Comal County OSSF Inspection Sheet

Permit#: 181017 Location: 550 High Dr

Re: Comal Hills Unit 1 Lot 17 Block 5, Permit #101017,
Application for Permit of Authorization to Construct On-Site Sewage Facility and
License to Operate

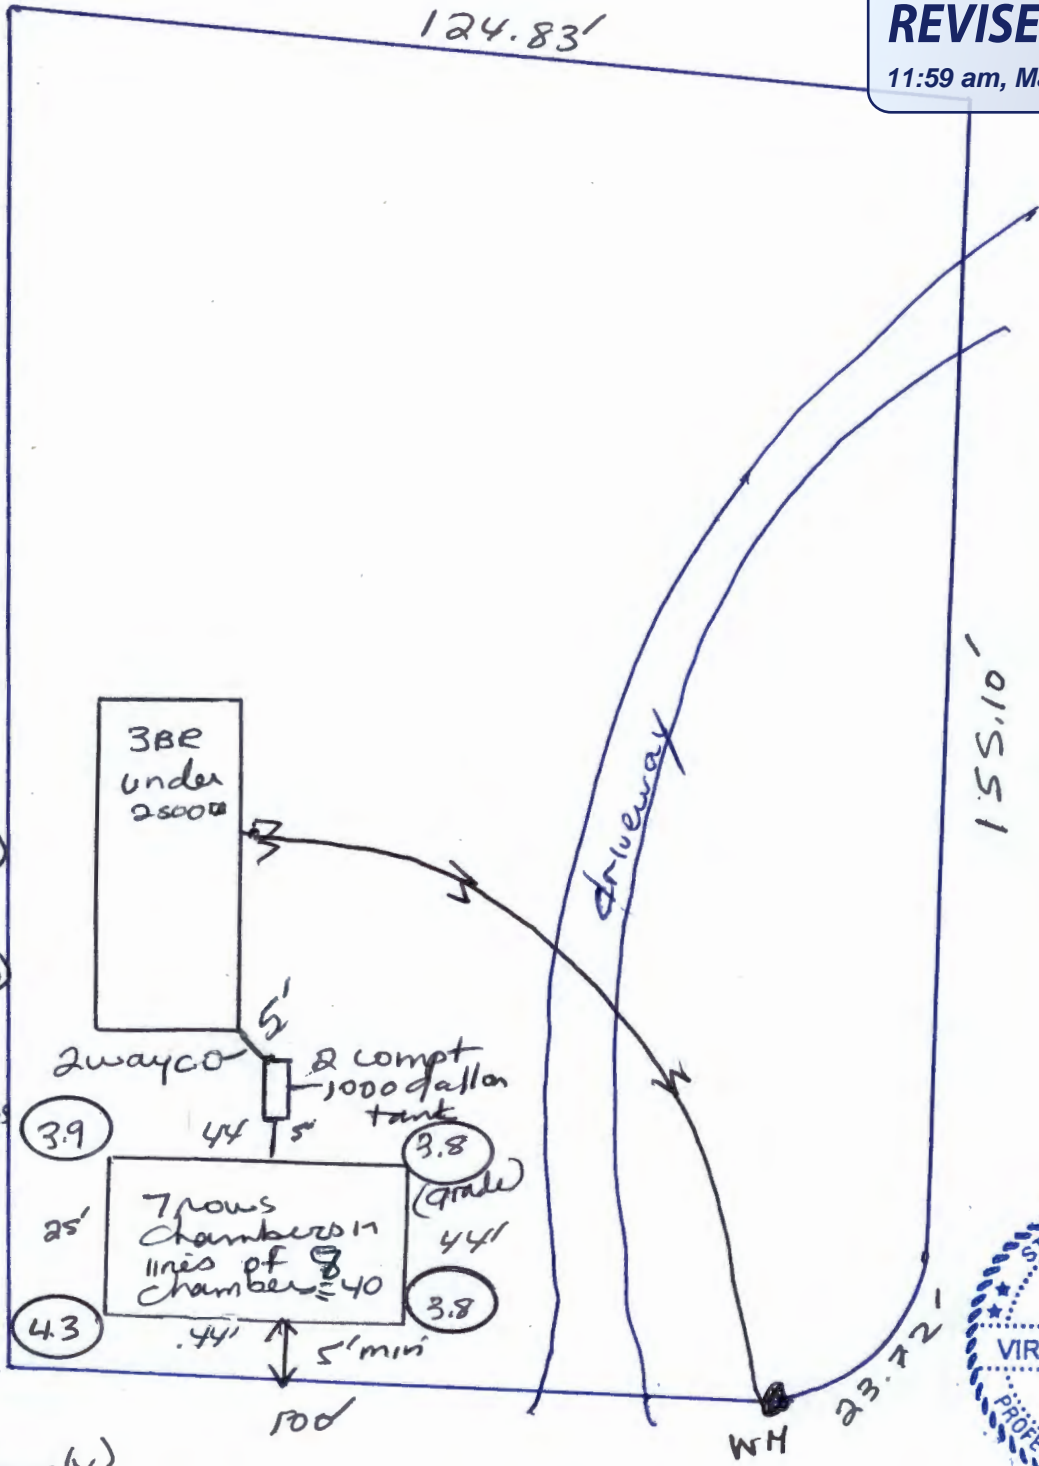
1. The soil conditions indicated on the soil evaluation are not suitable for the type of system designed.
2. Leaching chambers must cover the entire excavation.

240 gal
 - .2 (best soil)
 1200 #
 x .75 (25% reduction)
 900 #
 excavation
 25' x 44'
 21" wide chambers
 35' long
 (chambers are in units of 5')
 area covered by chambers
 21
 x 40' bottom
 + 80' sidewalks (sides only)
 920 # total
 42 total chambers
